Re: FortisBC Energy Inc. (FEI)

Filing of Biomethane Purchase Agreements between FEI and Tidal Energy Marketing Inc.

Response to the British Columbia Utilities Commission (BCUC) Panel Information Request (IR) No. 1

Simplified Illustrative Diagram – Displacement (Before)

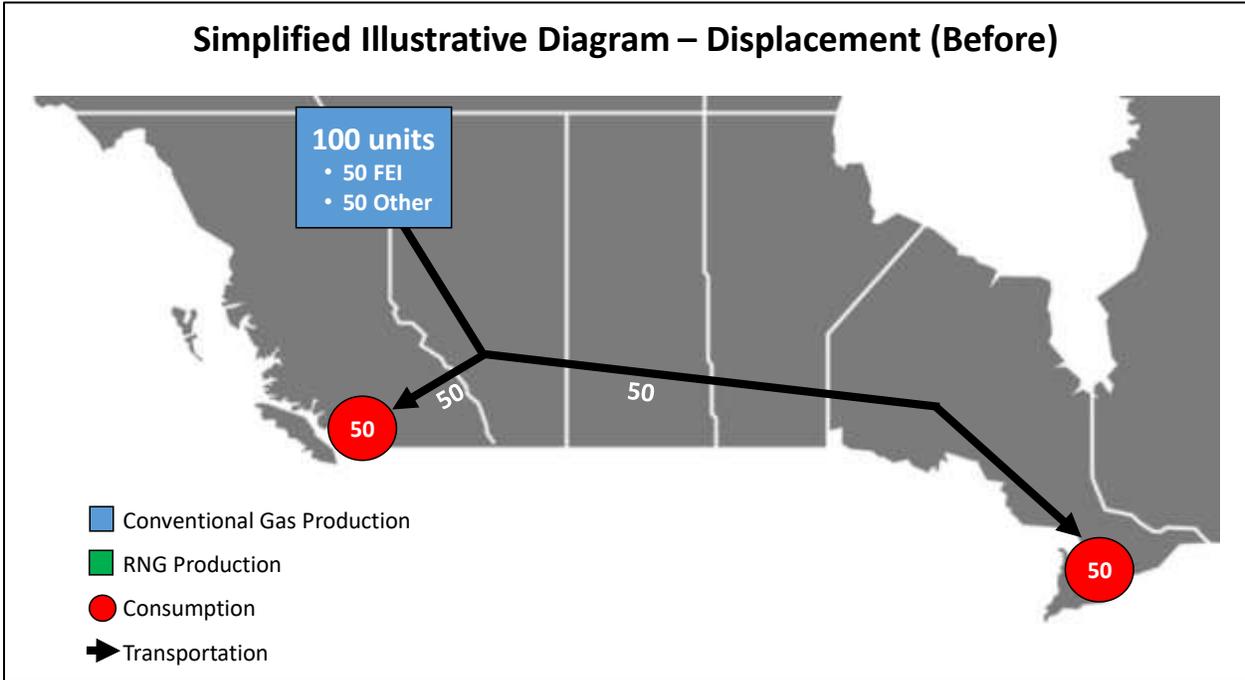
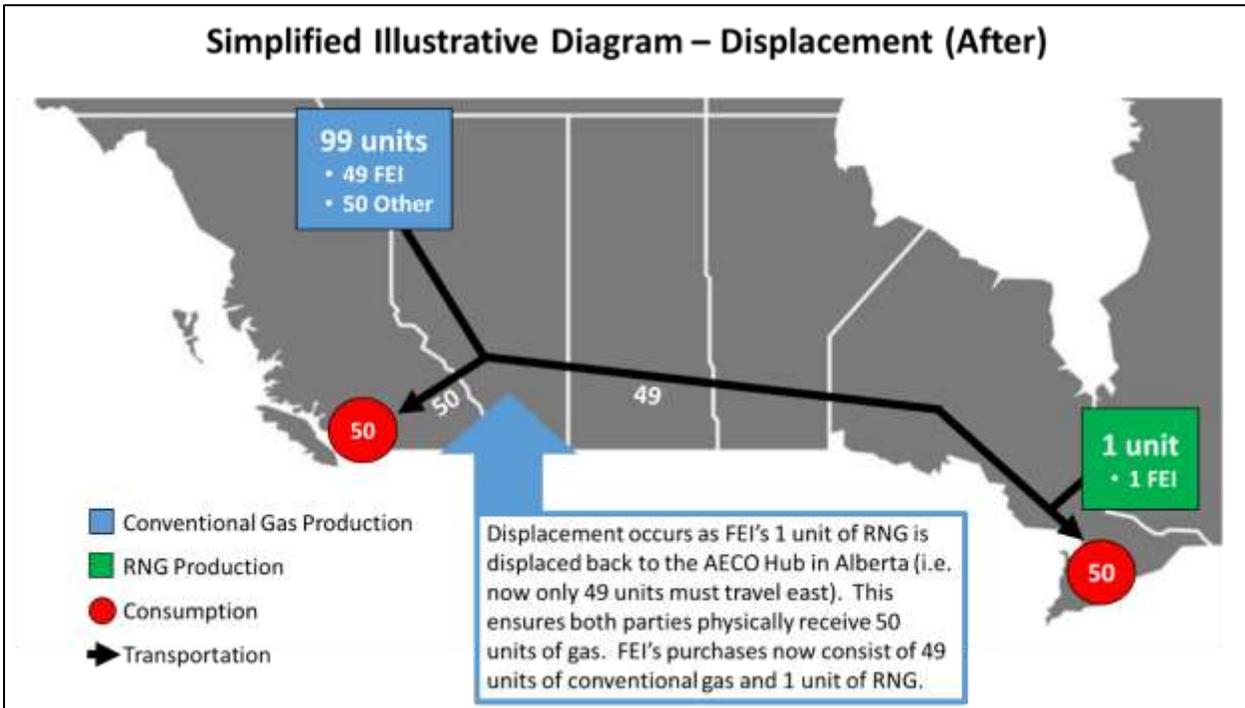
18 1.3 Please describe how RNG injected into pipelines at Niagara Falls and London,
19 Ontario, will physically displace conventional natural gas from entering BC's
20 pipeline network.

23 The RNG produced at the facilities in Ontario will cause an equivalent reduction in the amount
24 of gas that flows towards Ontario from Western Canada, thereby displacing conventional natural
25 gas molecules and reducing the amount of conventional natural gas that is produced and
26 injected into the system.

27 The diagrams below illustrate delivery by displacement. As illustrated in the diagram, the end
28 result is:

29 • A reduction in the flow of gas from west to east which reflects the delivery, by
30 displacement, of RNG to FEI; and

31 • A reduction in the amount of conventional natural gas that is produced and injected onto
32 the system.

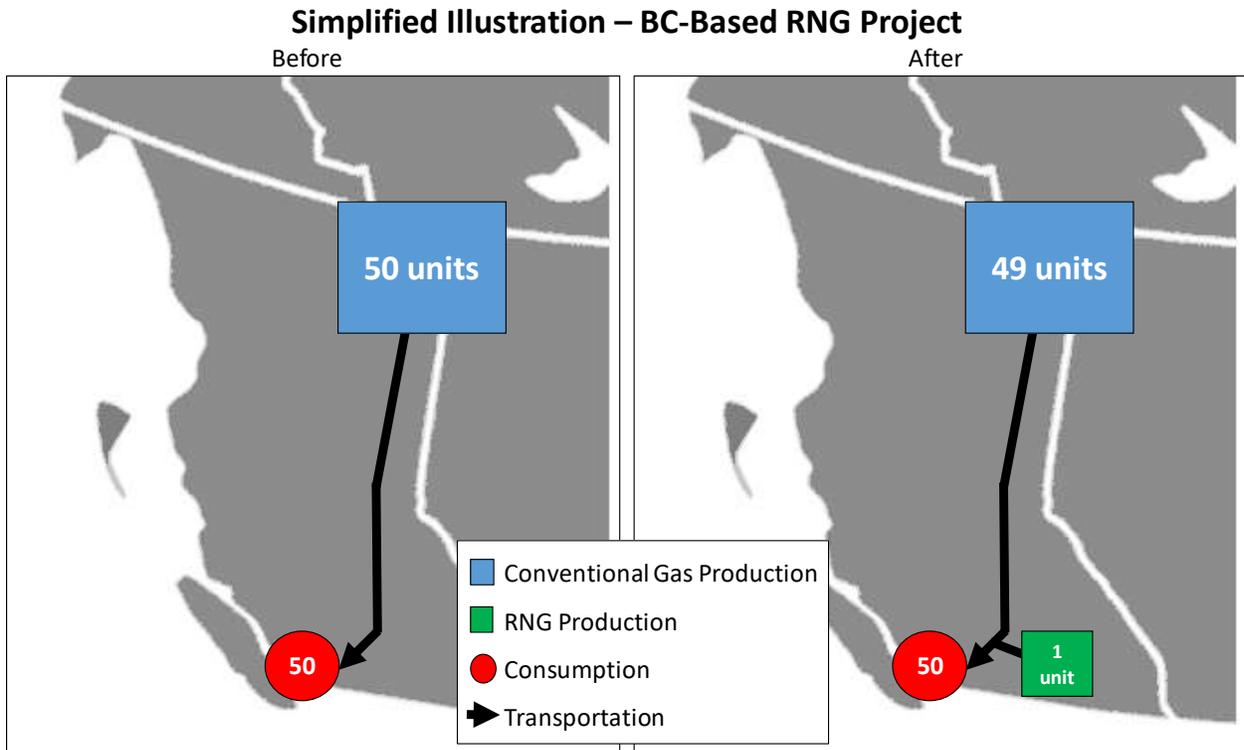
9 2.1 Please confirm whether the physical volume of greenhouse gases emitted into
10 the atmosphere at the end use is reduced when FEI customers use renewable
11 natural gas instead of conventional natural gas.

- 1 • Fraser Valley Biogas injects gas in the Eastern part of the Abbotsford natural gas system.
- 2
- 3 • An FEI customer in Prince George may purchase the RNG, and if required to report their
- 4 emissions to the BC Climate Action Secretariat, would be entitled to recognize the
- 5 associated emissions reduction.
- 6 • Due to the flow of gas in the immediate region and within BC generally, the end-use
- 7 customer in Prince George will not physically consume the RNG gas molecules they
- 8 purchased. Rather, the RNG is delivered notionally.
- 9 • However, the end result is a reduction in carbon emissions by avoiding the use of
- 10 conventional natural gas, which remains in the ground at the point of production in
- 11 locations such as British Columbia and Alberta.

12
13 Please refer to the simplified illustrative diagram below:
